## **Revised Responses to TR RAIs Dated May 28, 2010**

### **Meteorology**

Figure TR RAI 2.5-1c-1: Newcastle 9-Year and 1-Year Wind Roses

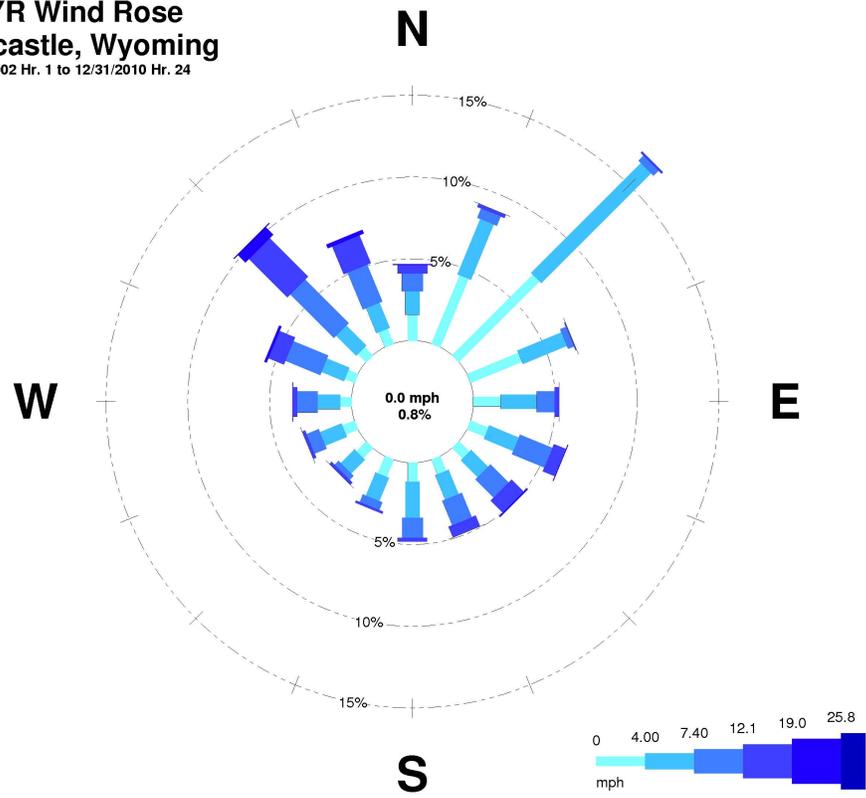
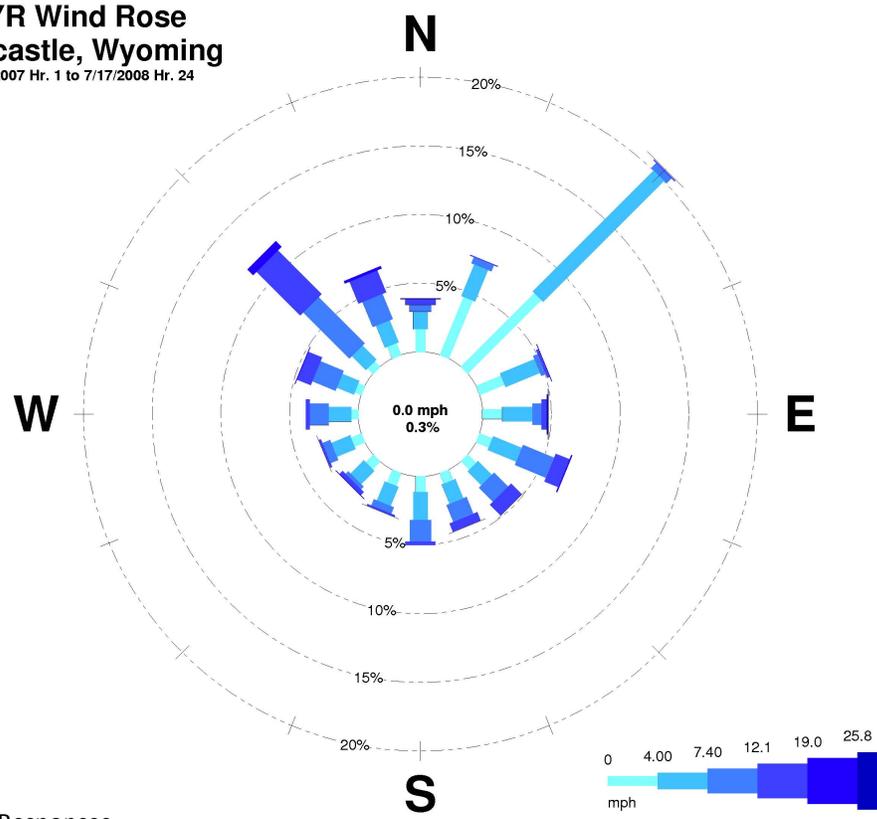
*Regulatory Guide 3.63 recommends comparing a concurrent period of meteorological data from a National Weather Service (NWS) station with the long-term meteorological data from that NWS station. The NWS station selected for this comparison should be in a similar geographical and topographical location and be reasonably close (preferably within 50 miles) to the site. Regarding the long-term representativeness of the data collected onsite, please address the following issues.*

Figure TR RAI 2.5-1c-1 shows wind roses at the Newcastle station for the nine full years of monitoring and for the one year corresponding to the Dewey-Burdock baseline monitoring period. Figure TR RAI 2.5-1c-2 presents a graphical comparison of short and long-term wind direction distributions. Both figures demonstrate qualitatively that the period from 7/18/2007 to 7/17/2008 is representative of the longer term.

**Figure TR RAI 2.5-3-1: Comparative Atmospheric Stability Methods for Dewey-Burdock**

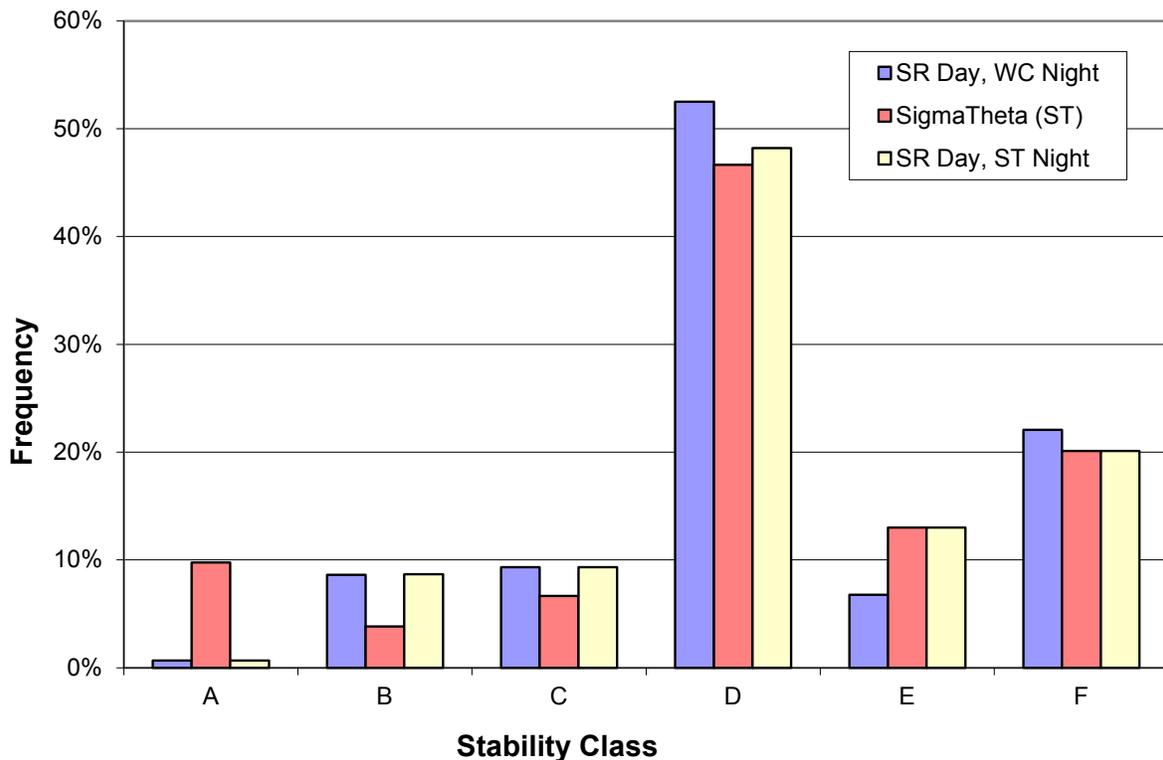
***Regulatory Guide 3.63 recommends that quarterly and annual wind direction, wind speed, and atmospheric stability data be compiled in joint frequency and joint relative frequency (i.e., decimal frequency) form for heights representative of effluent releases. In addition, stability categories should be established to conform as closely as possible with those of Pasquill. Please provide this data consistent with Regulatory Guide 3.63 or provide justification for an alternate methodology.***

Having developed these hourly  $\sigma_\theta$  values, the choice remained whether to use the sigma theta method exclusively, or to use a hybrid method that takes advantage of solar radiation (SR) data during the daytime. To facilitate this choice, the two methods were compared along with the original method which used SR during the day, and assumed worst-case delta-T (WC) at night. Figure TR RAI 2.5-3-1 shows the results of this comparison.

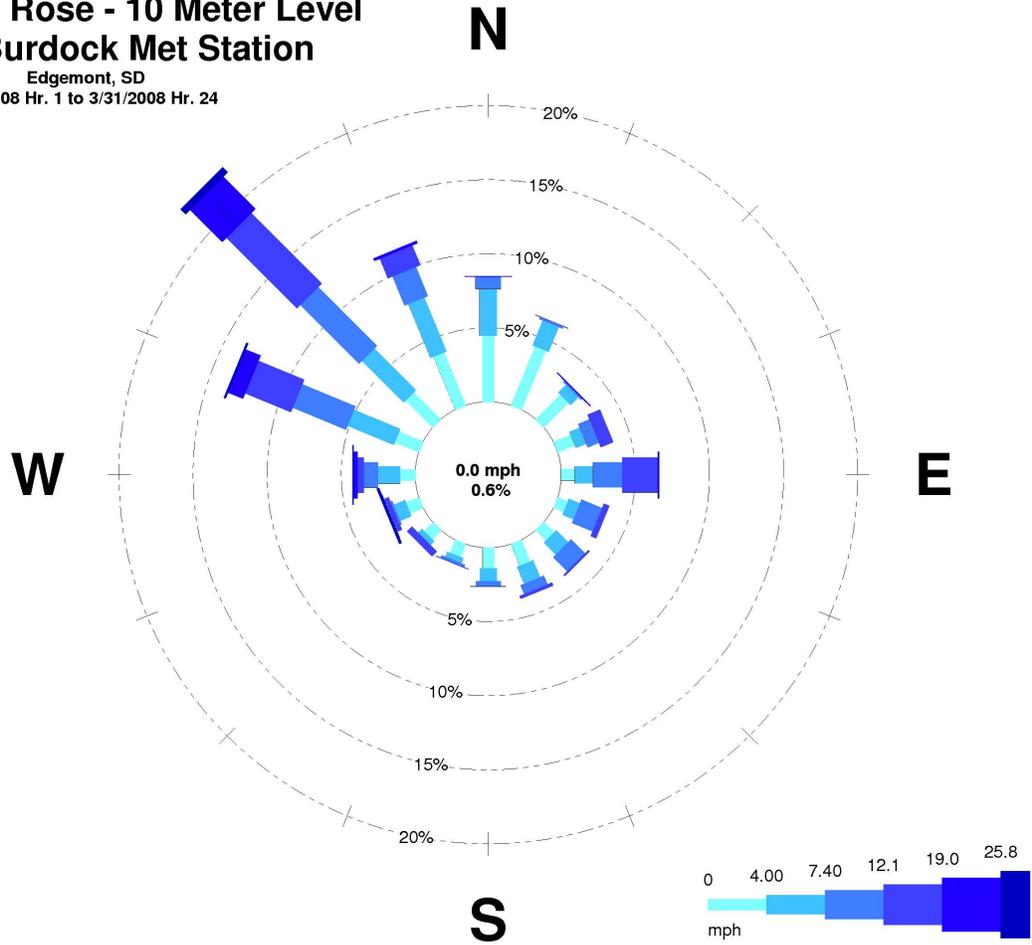
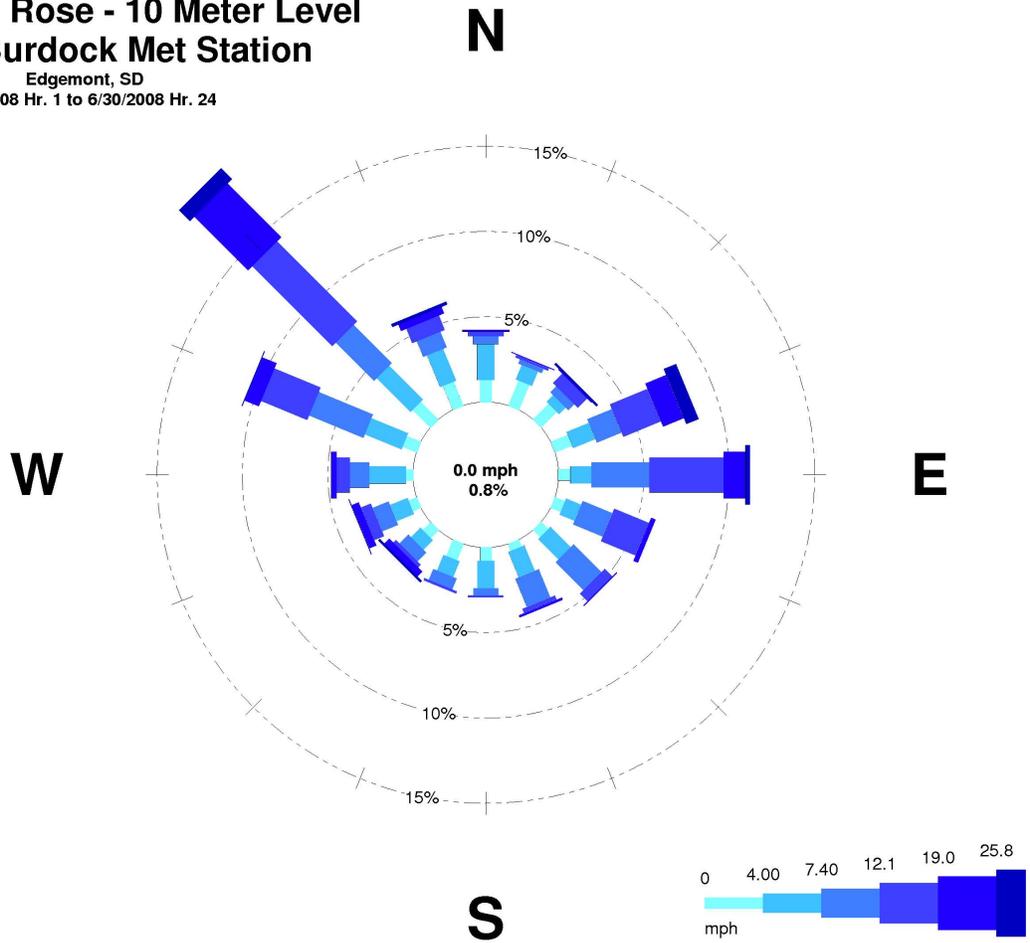
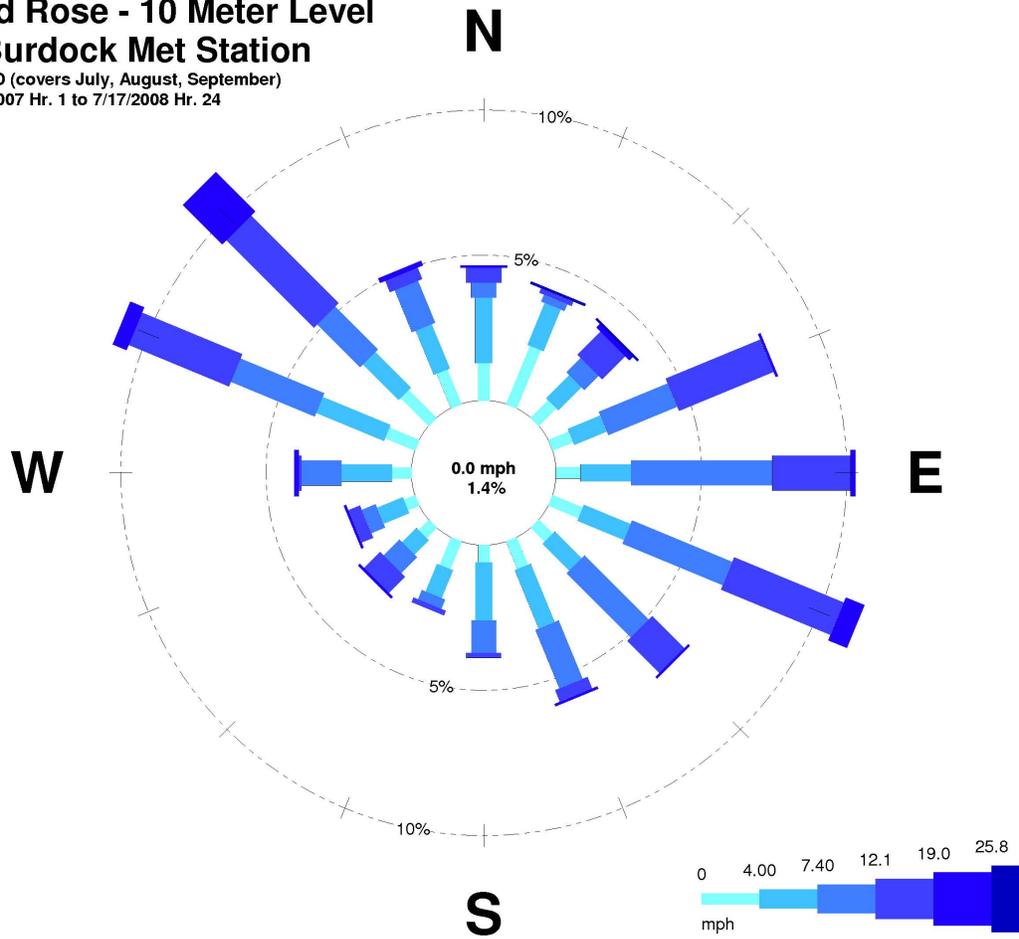
- b. Also on page 2-83, the applicant discusses wind data for the months of May and December. However, this data cannot be confirmed because the data in Table 2.5-7 appears to be a yearly tabulation while the data in Figures 2.5-22 and 2.5-23 are seasonal. Please provide data to confirm the applicant's statements for wind data.***

Figures TR RAI 2.5-4-3 through TR RAI 2.5-4-6 show the quarterly wind roses for the Dewey-Burdock project area, also at the 10-meter height. The period from January through March was used for the 1<sup>st</sup> Quarter, April through June for 2<sup>nd</sup> Quarter, July through September for 3<sup>rd</sup> Quarter and October through December for 4<sup>th</sup> Quarter. The summer wind rose reflects hourly data from both 2007 and 2008.

Figures 2.5-22 and 2.5-23 in the TR have been replaced by Figures TR RAI 2.5-4-3 through TR RAI 2.5-4-6 in the response to TR RAI 2.5-4. The revised figures show the quarterly wind roses for the Dewey-Burdock project area at the 10-meter height. The period from January through March was used for the 1<sup>st</sup> Quarter, April through June for 2<sup>nd</sup> Quarter, July through September for 3<sup>rd</sup> Quarter and October through December for 4<sup>th</sup> Quarter. The 3<sup>rd</sup> quarter wind rose reflects hourly data from both 2007 and 2008.

**Figure TR RAI 2.7-2-1**

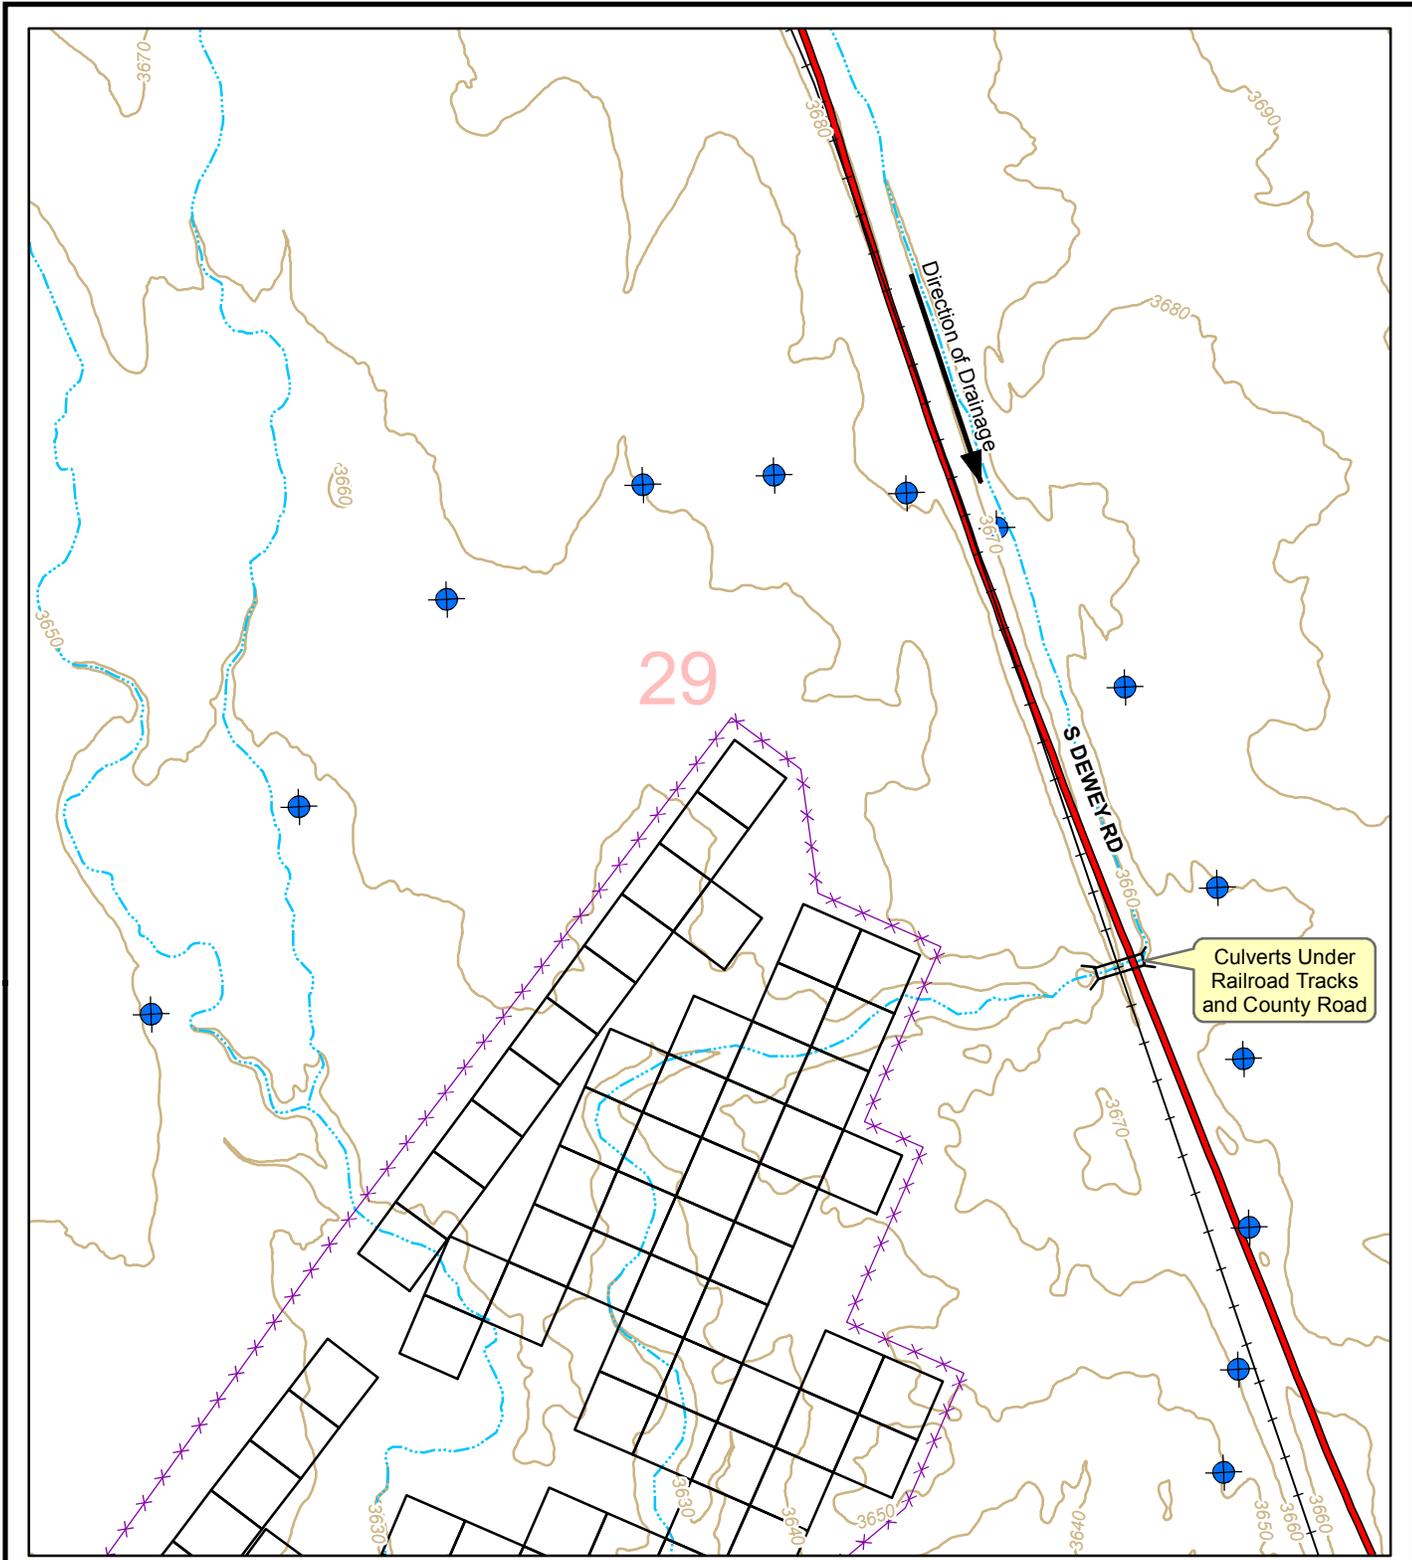
***Exhibit 3.2-1 of the TR Supplement indicated that the horizontal excursion monitoring well ring for Dewey Well field #1 is traversed by a set of railroad tracks. Staff was uncertain of the surface drainage in the topographic low areas on the northeast side of the tracks and whether the construction of the tracks includes any type of drainage system you might see for a double track construction (i.e., surface and/or subsurface drainage system). Staff is uncertain if standing water in poorly drained areas will hamper access to wells and potentially facilitate well leakage. Please clarify the surface drainage of this area.***

Figure TR RAI 2.7-2-1 depicts the northern portion of proposed Dewey Well Field 1 area where some of the perimeter monitor wells will likely be located across a railroad and county road from the well field. Powertech investigated the drainage in this area in May 2011 and determined that there are culverts beneath the county road and the railroad which will prevent ponding of water near the monitor wells. The railroad culverts consist of two 5' x 6' rectangular box culverts. One 18" corrugated metal pipe culvert provides drainage for the county road. Despite an unusually high amount of rainfall during May 2011, no ponded water was observed in this area. The monitor wells will be located outside of the drainage channel and will not be subject to flooding. Adequate access to the perimeter monitor wells will be available even during infrequent storm events that trigger ephemeral flow through the railroad and county road culverts.

Note that the potential well field and monitor well locations shown on Figure TR RAI 2.7-2-1 are only conceptual locations at this time. A revised, detailed design will be provided in a well field hydrogeologic data package.
